# SAFETY RECALL BULLETIN

NHTSA RECALL 18V889, TRANSPORT CANADA RECALL 2019015

AUTOCAR, LLC SAFETY RECALL ACX-1901

Autocar has determined a defect that would present an unreasonable risk to safety exists due to potentially improperly torqued universal joint strap bolts on certain model year 2019 Xpeditor vehicles.

**Figure 1, Transmission Location**

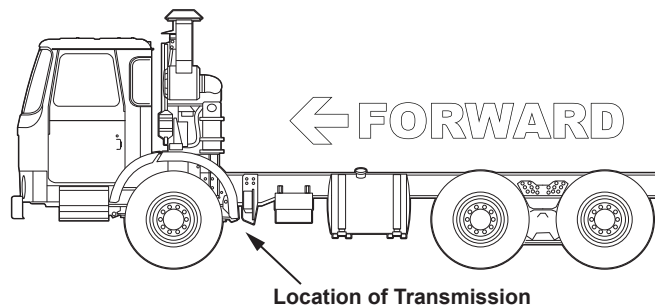
1. Follow all lock out procedures and chock the wheels.
2. From underneath the vehicle, locate the transmission output yoke at the rear of the transmission and the universal joint strap bolts (see *Figure 1* and *Figure 2*).

**Figure 3, Universal Joint Strap Bolts Tightening Sequence**

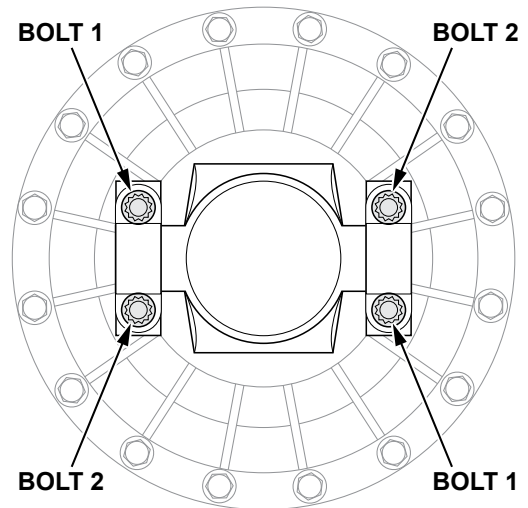
3. Starting with either position 1, tighten the universal joint strap bolts in a counter clockwise sequence to 125 lbs.-ft. of torque (see *Figure 3*).
